Department of Public Works City Engineering Division December 19, 1997

Re: Petition No. 2275. General Services Administration — Federal Protective Service Division (GSA), Barricade Blockage of Streets — Encroachments, First and Howard — near federal government buildings; also requesting permission to maintain one existing guardhouse encroaching into the public sidewalk space on the north side of Howard, east of First.

BARRICADE PUBLIC STREET CLOSINGS

PETITION NO. 2275
GENERAL SERVICSE ADMINISTRATION
REGION 5, CHICAGO
C\O MANETTE MYERS
PHONE: 313-353-5637
(LOCAL CONTRACT) CAROL DOMINO 313-226-4912

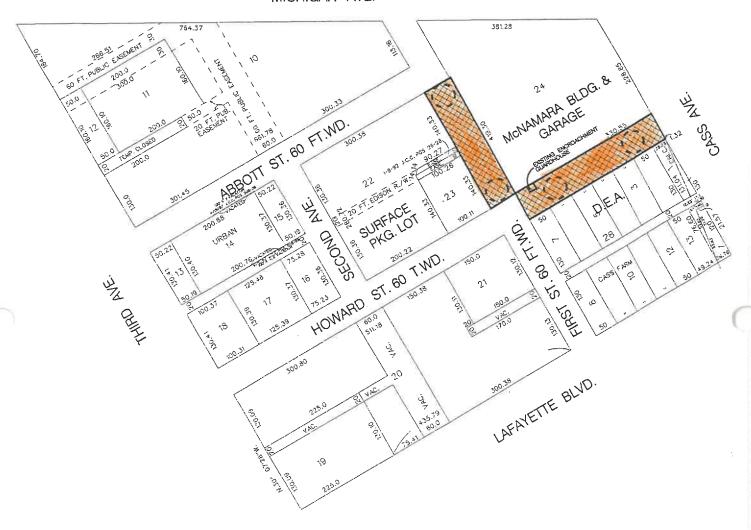
Whereas, Traffic Engineering Division - DPW (in a reply dated 8/29/97) says: "Involved; have no objection to the proposed temporary closing portions of First Street, and Howard Street as detailed in the attached drawing No. 2275 provided that 100% of the abutting property owners' signatures are secured. First Street between Lafayette and Howard must be changed from one-way operation to twoway operation before the portion of Howard is closed. The Traffic Engineering Division will be able to complete the necessary changes along First Street within 60 days [reply by Dennis Zawaski, Assistant Director]. The owner of the abutting lots shown on the referenced drawing is the federal government and/or its interests. City Engineering Division -DPW prepared the resolution below primarily on the basis of the quoted Traffic Engineering reply. Traffic Engineering Division — DPW shall assume full responsibility for their evaluation of a petition that barricades two public streets for an undetermined time period; and
